Project	IEEE 802.16 Broadband Wireless Access Working Group http://ieee802.org/16>
Title	Corrections to Figure 87
Date Submitted	2005-06-25
Source(s)	Lei Wang, Adam Newham Voice (760)448-1984 Cygnus Multimedia Communications, Inc. Fax: (760)448-1989
	John Lee, Yongmao Li Huawei
Re:	This is a contribution to IEEE 802.16 Cor1.
Abstract	For the OFDMA PHY CDMA-based initial ranging, the timer T9 shall be started at BS after sending RNG-RSP (success).
Purpose	To correct Figure 87.
Notice	This document has been prepared to assist IEEE 802.16. It is offered as a basis for discussion and is not binding on the contributing individual(s) or organization(s). The material in this document is subject to change in form and content after further study. The contributor(s) reserve(s) the right to add, amend or withdraw material contained herein.
Release	The contributor grants a free, irrevocable license to the IEEE to incorporate material contained in this contribution, and any modifications thereof, in the creation of an IEEE Standards publication; to copyright in the IEEE's name any IEEE Standards publication even though it may include portions of this contribution; and at the IEEE's sole discret

Figure 87 CDMA Initial Ranging -- BS

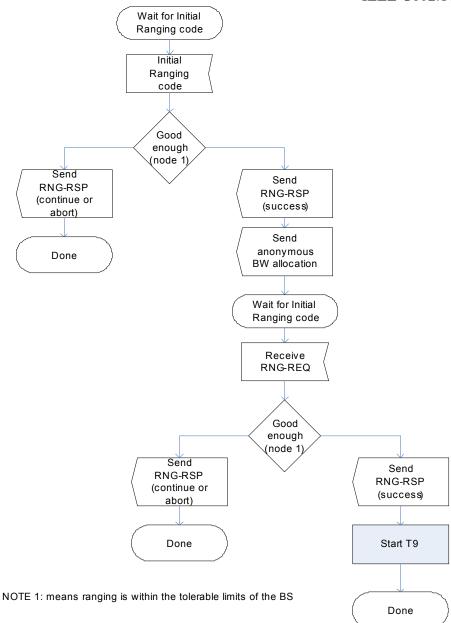
The timer T9 shall be started at BS after sending RNG-RSP (success) to the SS during initial ranging. However, in Figure 87 of IEEE Std 802.16-2004 for the OFDMA PHY CDMA-based initial ranging, the timer T9 was not started at all. This contribution provides a modified Figure 87 to correct this problem.

In Cor1/D3, page 57, line 32, insert the following:

Replace Figure 87 with the following figure:
